**Re: Response to Department's Comments
HDD S2-0010, E65-973
Loyalhanna Lake Crossing
Loyalhanna Township, Westmoreland County**

Re: Response to Department's Comments
HDD S2-0010, E65-973
Loyalhanna Lake Crossing
Loyalhanna Township, Westmoreland County
Comment No. 3

Figure 1. Portion of HDD S2-0010-16 Plan and Profile showing steepening of slope (red ellipse on profile)

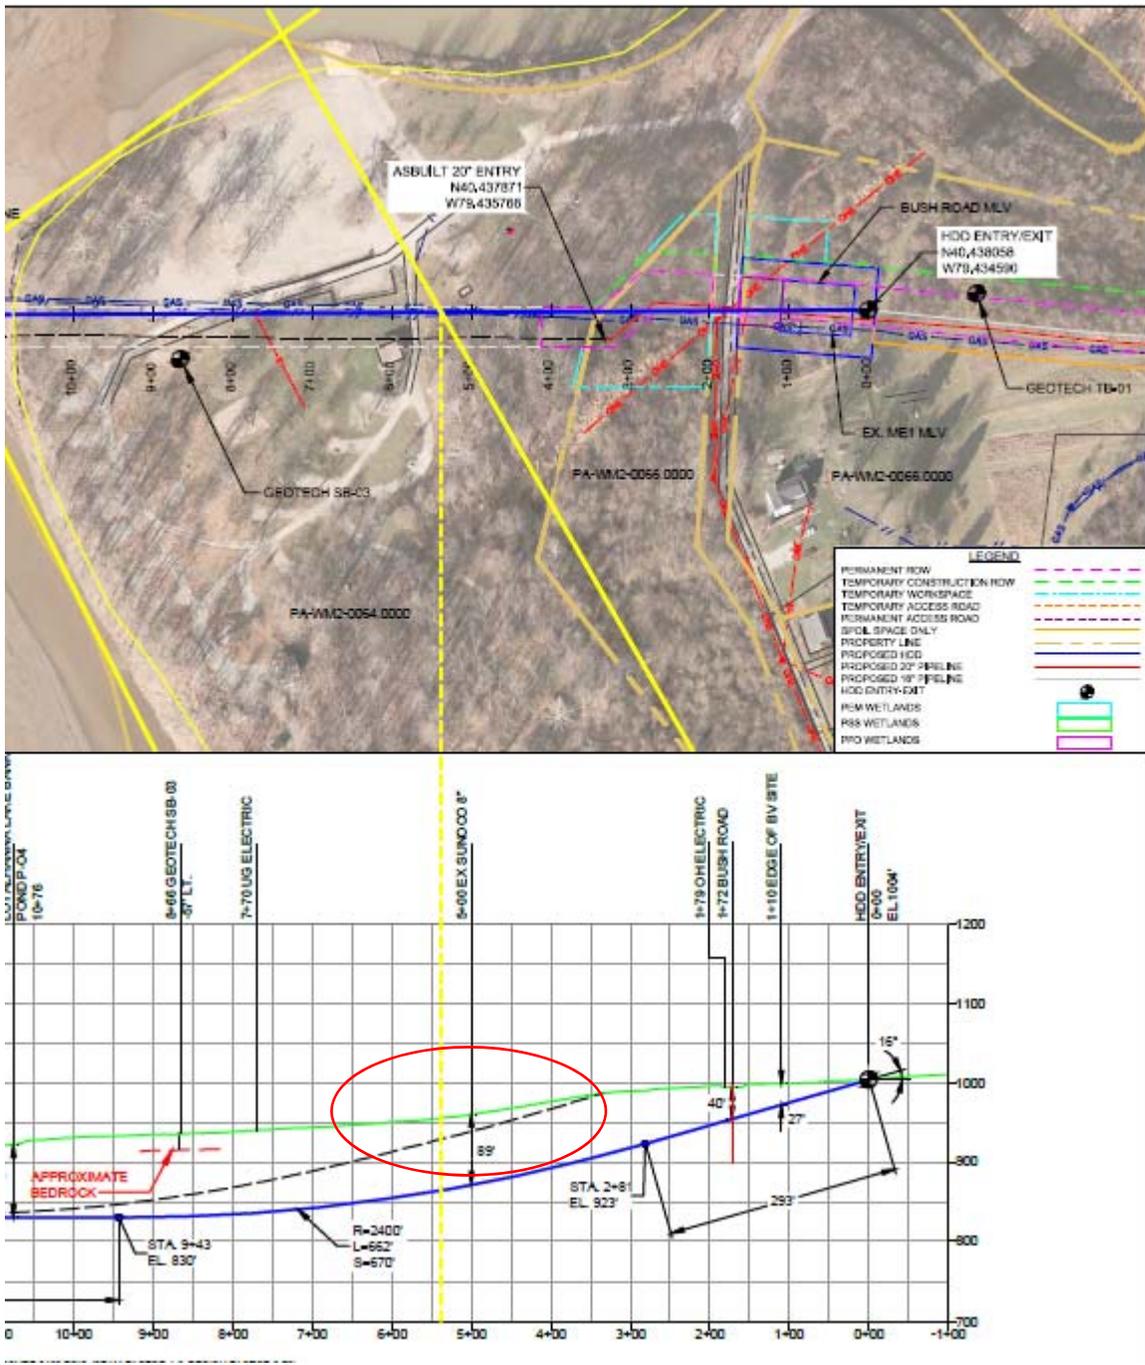
- 3. In Section 3.1.2, SPLP mentions the potential existence of a quarry high wall just west of the eastern entry/exit pit that may have contributed to the inadvertent returns (IRs) during installation of the 20-inch line. What level of investigation was conducted by SPLP to confirm the existence of the high wall and to understand its history? Please identify the location of the high wall as it relates to the locations of the IRs that occurred during installation of the 20-inch line.***

During the construction of the 20-inch pipeline at HDD S2-0010 and IRs that occurred east of Loyalhanna Lake it was rumored by local by-stander that the pilot boring may have passed through a former historic quarry high wall and quarry workings. Along the alignments of HDs S2-0010 and S2-0010-16 the topographic gradient between Bush Road and parking lot for boat launch at Loyalhanna Lake steepens over a distance of about 200 feet (see Figure 1). This steepened slope runs parallel to the lake shoreline from the intersection of Bush Road and the boat launch entrance road, south approximately 2,300 feet. The pipeline right-of-way crosses the steepened slope approximately 220 feet south of that intersection. Historic aerial photography and historic topographic maps were examined for evidence that this steepened slope might represent the location of the former quarry rumored to exist by the by-stander at this location.
